# Doncaster Avenue Student Accommodation Modification 1

Modification to the location of the on-site detention tank,  
alignment of the Sydney Water easement, internal changes  
within the basement and associated landscape  
amendments

State Significant Development Modification Assessment  
(SSD 9649 MOD 1)

**Figure 3 |** Proposed Location of the OSD tank and modifications to the basement – OSD tank shown in the red bubbled outline (Source: Applicant's Modification Report)

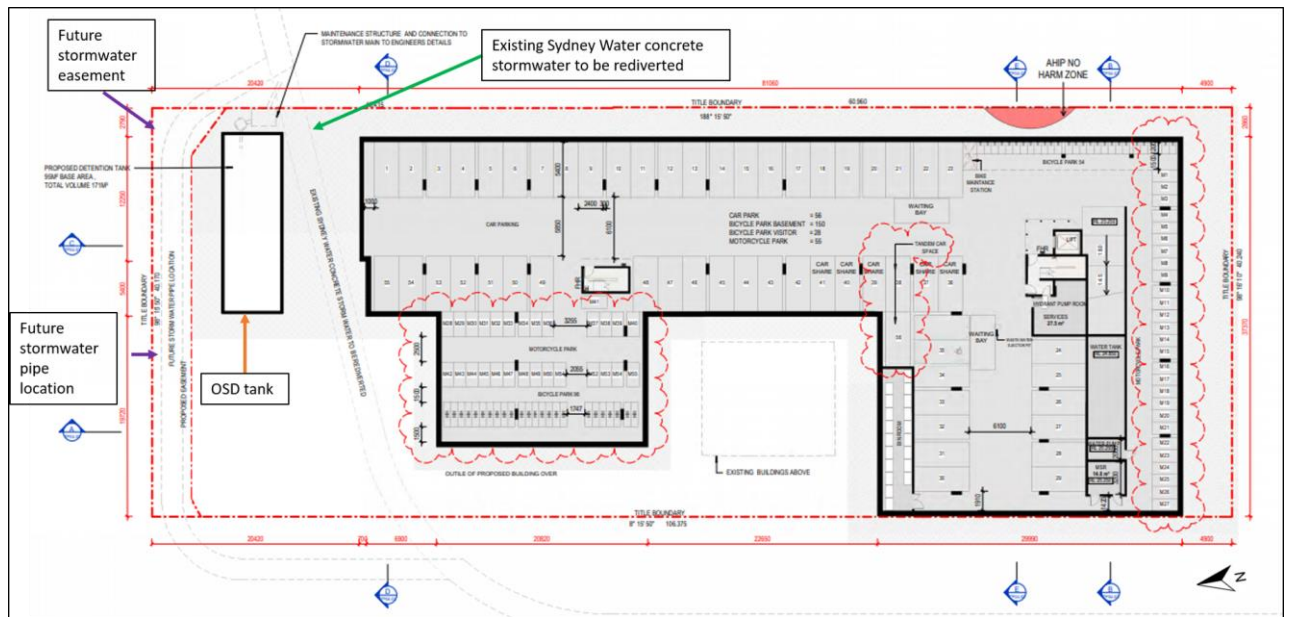
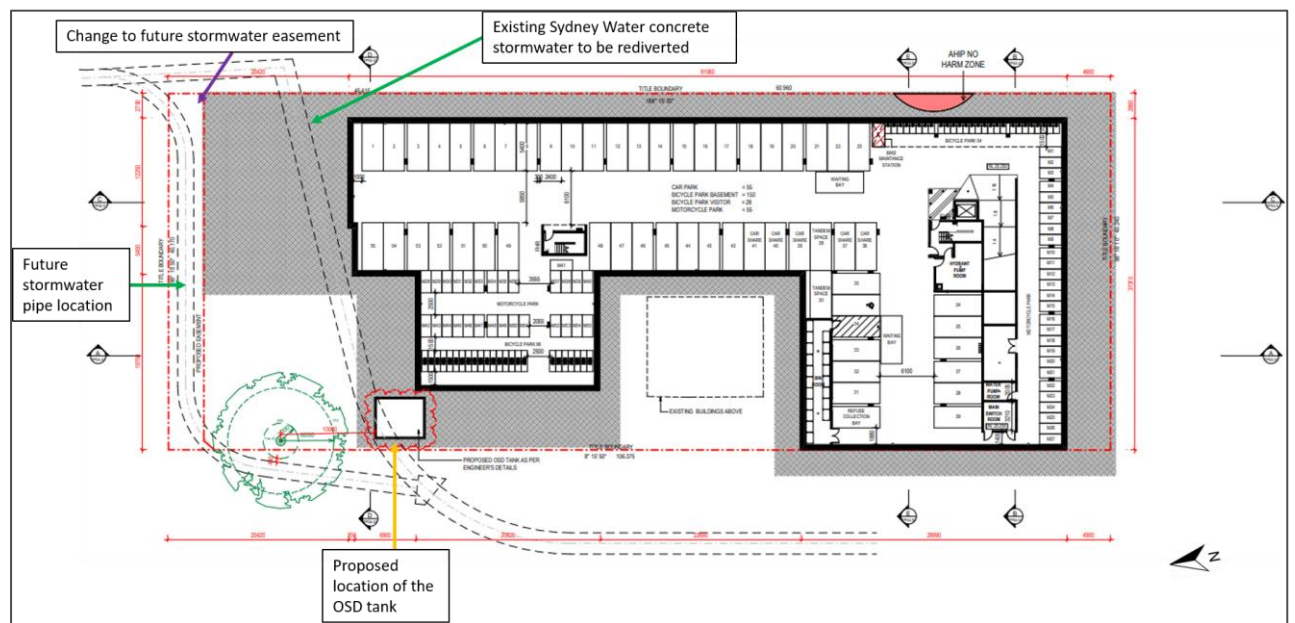
Issue	Findings	Recommendations
<b>Relocation of OSD tank and realignment of easement</b>	<ul style="list-style-type: none"> <li>• The proposal seeks to relocate the OSD tank from the north eastern corner of the site to the western edge of the site within the Doncaster Avenue setback and realignment of the stormwater easement to accommodate the OSD tank.</li> <li>• Council raised no objection to the amendments as the design and sizing of the OSD tank will be in accordance with Council's requirements and submitted to the Certifier in accordance with existing conditions of consent.</li> <li>• The Department supports the relocation of the OSD tank and realignment of the easement as: <ul style="list-style-type: none"> <li>○ there are no permanent structures located along or within 1m from the outside edge of the new stormwater channel</li> <li>○ it will be located underground and will not result in any visual impacts</li> <li>○ it is located in the lower portion of the site and setback from the building improving drainage, minimising potential flood impacts and improving access for maintenance</li> <li>○ the OSD will be designed in accordance with Council requirements as outlined in conditions B68, B69, B70 and B71</li> <li>○ the deviation of the Sydney Water Stormwater Channel is required to be undertaken in accordance with Condition B45 which requires agreement from Sydney Water</li> </ul> </li> </ul>	The Department recommends condition A2 be amended to reflect the basement plan.

- The existing conditions of consent require the existing Sydney Blue Gum tree to be retained with only limited pruning permitted.
- The relocated OSD tank is located a minimum of 10 m from the centre of the Sydney Blue Gum tree.

- The Applicant provided an Arboricultural Report providing an assessment of the impacts of the proposal on the Sydney Blue Gum and recommended that:
  - excavation works be limited to the construction footprint

- The Department has considered the Applicant's Arboricultural Report and is satisfied that the OSD tank is sufficiently setback from the centre of the tree and appropriate measures will be implemented to protect the tree during excavation and construction works associated with the OSD.

- the OSD tank will allow sufficient soil depths for the two proposed trees and screen planting within the front setback.
- The Department recommends condition A2 be amended to reflect the amended basement plan and notes that as there are no permanent structures located along or within 1m of the new stormwater channel, a new condition is not required.

- The Department recommends condition C24 is added and conditions B82 and D38 are updated to require implementation of the recommendations of the Arboricultural Report.

**Figure 5 | Extract of Proposed Landscaping – lawn area raised to generally align with surrounding levels (Base source: Applicant's RtS)**

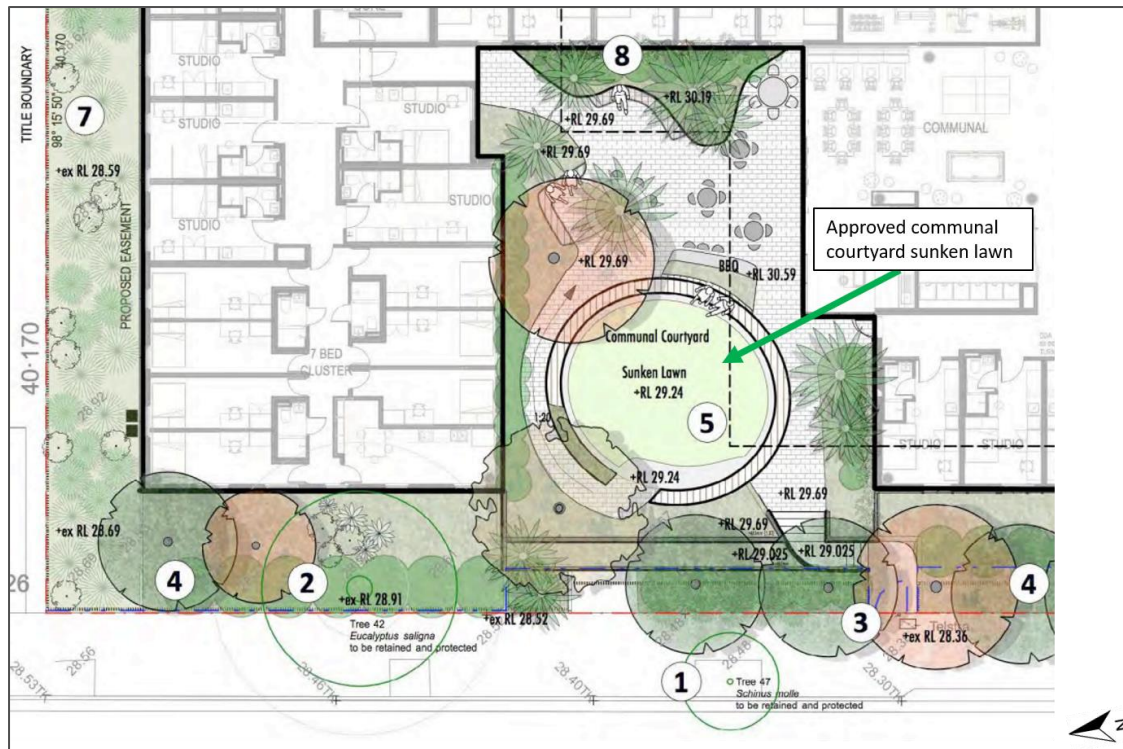
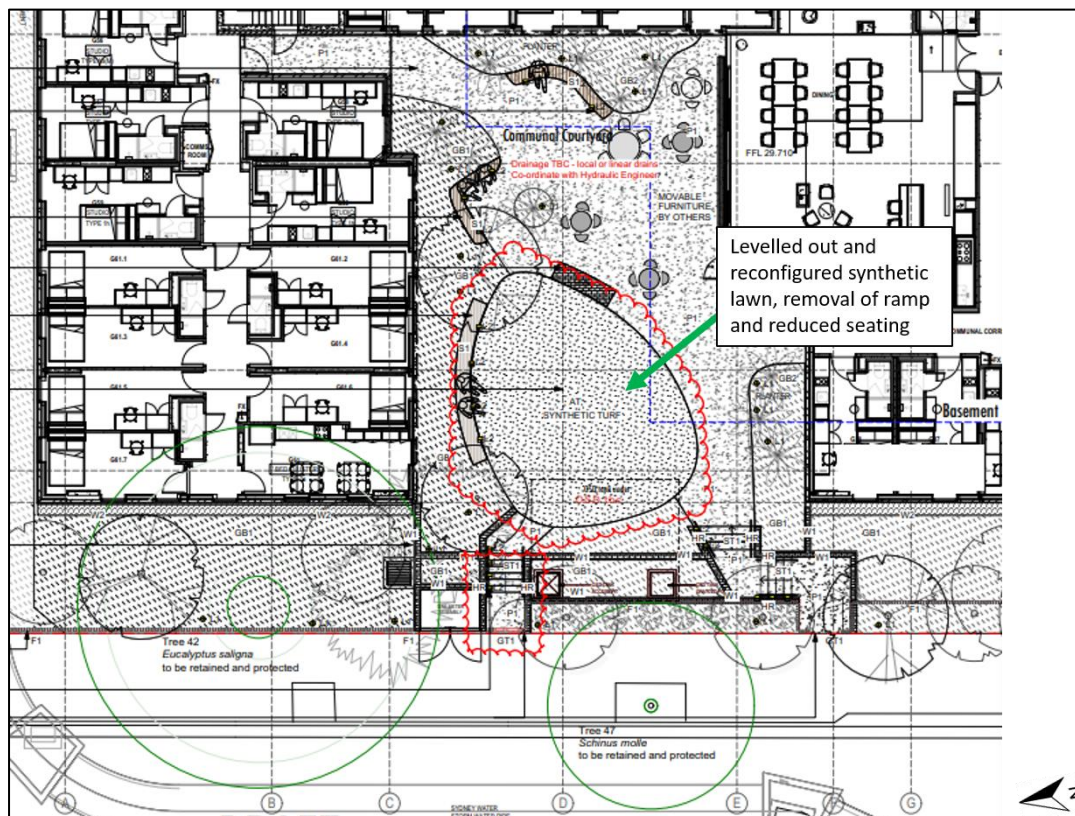
- The proposal seeks to:
  - raise the level of the sunken lawn area within the front communal courtyard area by approximately 360mm, to be generally consistent with the approved surrounding lawn and accommodate the OSD tank

- replace the approved lawn with synthetic grass to improve usability of the space and reduce risk of grass growth affecting the OSD tank.
- Council did not raise any objection to the changes.

- The Department supports the proposed amendment to raise the sunken lawn area as it is required to accommodate the relocated OSD tank, will generally align with the surrounding levels and will result in negligible visual or other impacts.

- The Department however considers the proposed change from natural grass to synthetic grass would be inconsistent with the approved high-quality landscape design.

- In response, the Applicant agreed to a condition requiring natural grass be used.
- The Department also notes the proposed landscape changes were provided on a partial plan, which also includes elements of the development not assessed as part of this modification.

The Department recommends new condition B1A requiring submission of an updated landscape plan which includes the redesign of the approved lawn area, landscaped with natural grass.

- The Department therefore recommends new condition B1A requiring submission of an amended landscape plan reflecting the proposed changes to the lawn area and specifying the use of natural grass.
